**UNITED STATES OF AMERICA
BEFORE THE NUCLEAR REGULATORY COMMISSION**

_____)	
In the Matter of)	
)	
Proposed Rule: Waste Confidence –)	
Continued Storage of Spent Nuclear Fuel)	Docket No. 2012-0246
10 C.F.R. Part 51)	
)	
Draft Waste Confidence Generic)	
Environmental Impact Statement)	
_____)

**Comments by Environmental Organizations
on Draft Waste Confidence Generic Environmental
Impact Statement and Proposed Waste Confidence Rule**

Figure 1. Burnup trends for PWR and BWR reactors in the United States (Reproduced from IAEA 2011, Fig. 6 (p. 9), with note: Courtesy of Energy Resources International)

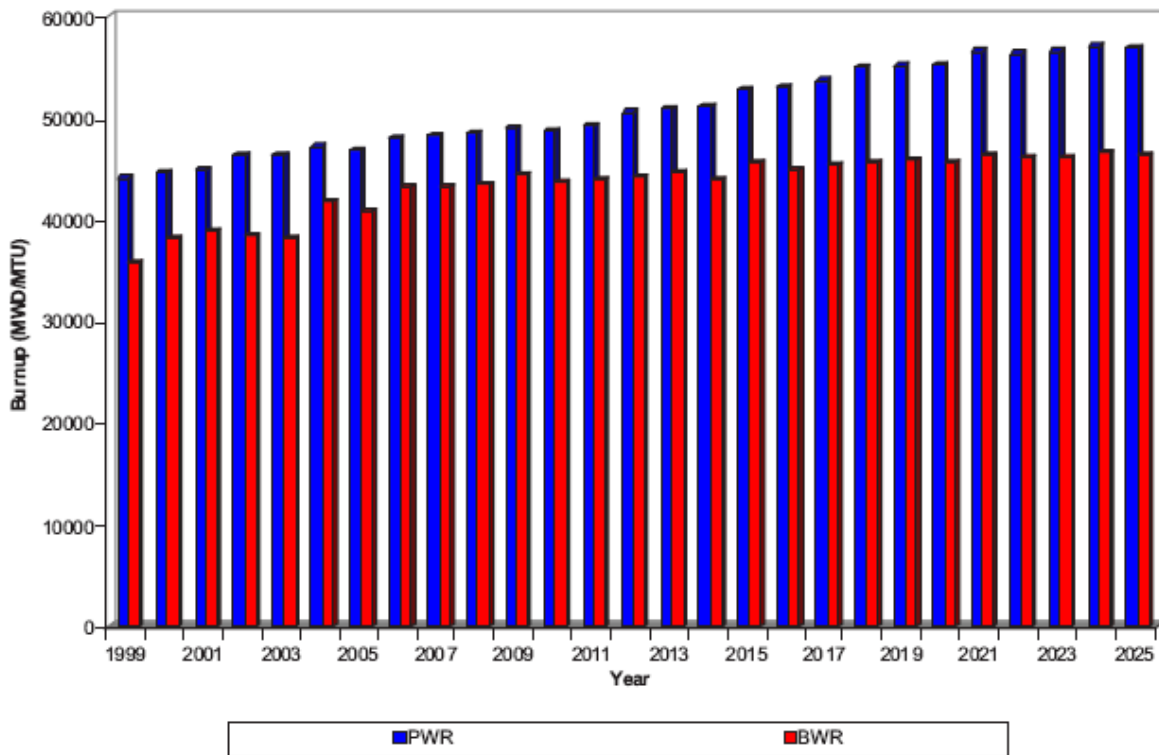
Figure 1 shows the trends in burnup for PWRs and BWRs. It shows that high burnup fuel (more than 45 GWd per metric ton) started being discharged from reactors only around the turn of the century. Most of this is still in spent fuel pools. Examination of high burnup spent fuel after dry storage of 15 years, as was done for low burnup Surry fuel,⁵³ is not yet possible, though some experimental work with high burnup fuel cladding has been done.⁵⁴

Figure 2. Cladding outer surface oxide thickness layer versus rod average burnup (Reproduced from NWTRB 2010, Figure 20 (p.56))

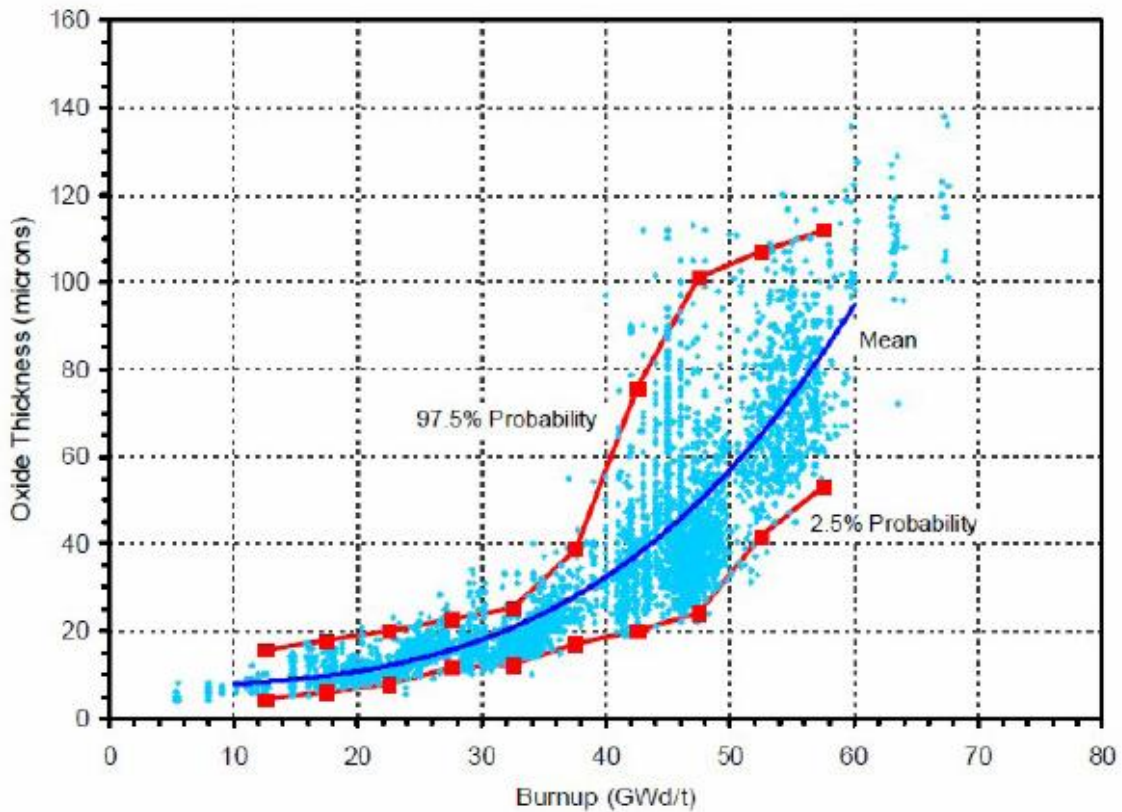
4.21. High burnup fuels also tend to build up much thicker levels of oxide during the in-reactor period as well as much higher levels of hydrogen in the cladding. Figure 2 below shows that the typical increase in outer oxide layer thickness increases from about 20 microns at 30 GWd/MTU to about 100 microns at about 62 or 63 GWd/MTU at discharge from the reactor.⁷² Moreover, the spread in the oxide layer thickness increases with burnup, indicating that some fraction of fuel rods may be at a much greater risk of failure.

about 70 microns to 130 microns, a spread of 60 microns. In fact these data show that the *variability* in oxide layer thickness at 63 GWd/MT burnup is almost *twice as large as the maximum* thickness at 30 GWd/MT. The oxidation and hydriding in-reactor data point to (i) a higher probability of failure and (ii) more severe failures in some fraction of the rods in cases when failures occur upon prolonged spent fuel pool and dry storage for high burnup spent fuel. High oxide and hydrogen levels in cladding create a host of vulnerabilities in spent fuel, including increased brittleness upon drying, high hoop stresses, and other phenomena that could cause fuel to fail – that is, to develop cracks and fissures that are significant enough to cause release of fission products. Reasonable confidence in the integrity of spent fuel after long periods of storage would not only require examination of typical high burnup fuel rods but also the ones at the higher levels of initial degradation that are clearly indicated by currently available information of in-reactor performance.

Figure 3. Maximum Wall Thickness Average Hydrogen Content in Low-Tin Zircaloy-4 Cladding (Reproduced from NWTRB 2010, Figure 21 p.56))

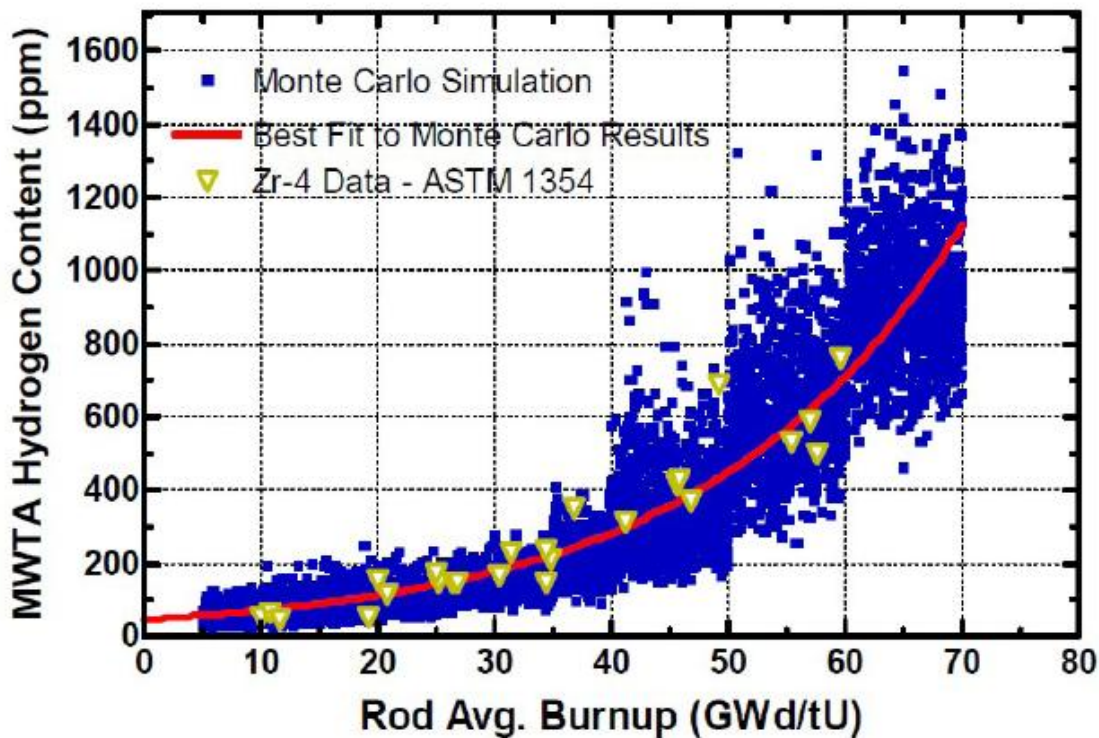
4.22. Figure 3 shows that the maximum wall thickness hydrogen content increases from 200 ppm to 800 ppm at discharge over approximately the same burnup range as in Figure 2. In both cases the variability is also much greater at the higher burnup. For instance, Figure 3 shows oxide layer thicknesses for a burnup of 30 GWd/metric ton ranging from roughly 12 microns to (at most) 35 microns – a spread of 23 microns. At 63 GWd per metric ton the thickness range from

Figure 2-4. Continued Storage Timeline

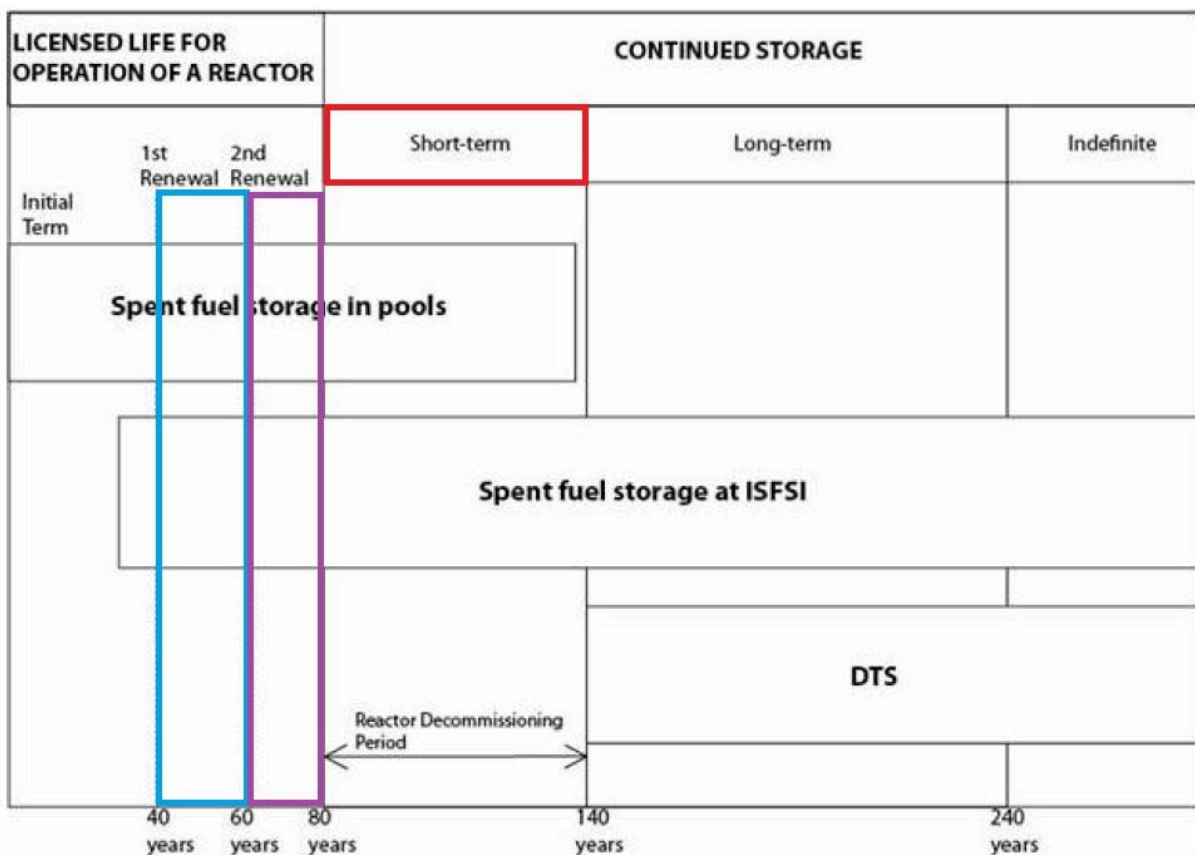
7.39 But the period of extended operation only covers the duration of reactor operation, not to the end of the 60-year short-term storage period as clearly illustrated in Figure 2.4 of the WC DGEIS:

Figure X-1
PWR Spent Fuel Storage Racks: Low-Density and High-Density Designs

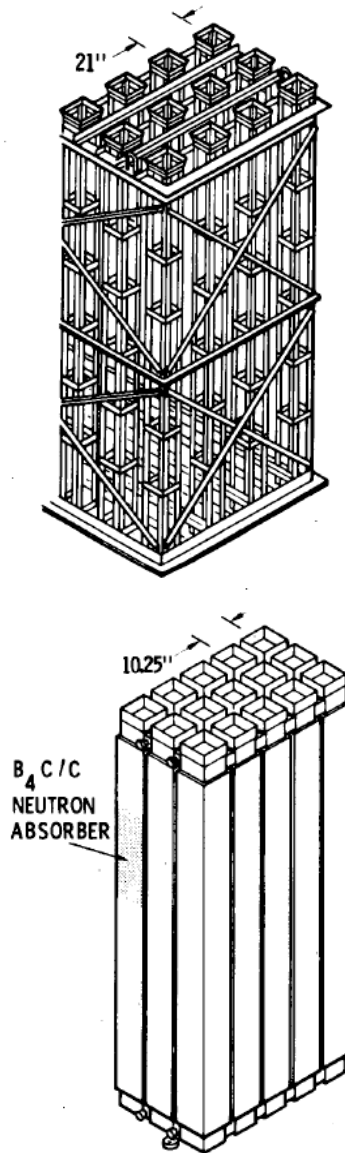
(X-8) As discussed in paragraph I-7, above, the pool serving each commercial reactor in the USA is now equipped with high-density, closed-frame racks. The nuclear industry began installing these racks in the 1970s, to replace the low-density, open-frame racks previously used. The high-density racks offered a comparatively cheap option for storing a growing nationwide inventory of spent fuel. Figure X-1 shows the configurations of the two types of rack.

(X-9) If water were lost from a pool equipped with high-density racks, the racks would inhibit heat transfer from the exposed fuel. Thus, spent fuel in the pool would increase in temperature, potentially leading to ignition and sustained combustion of zircaloy cladding in air or steam. To a technically trained observer, it should be obvious that ignition could be more likely if residual water were present in the pool, other factors being equal. Residual water would block the flow of air from below, thus reducing heat transfer from the exposed portion of the fuel. Figure X-2 illustrates this phenomenon. As a result, spent fuel with a comparatively high age after discharge from a reactor could burn if residual water were present. The initial phase of "burning" would, in this case, be a steam-zircaloy reaction.
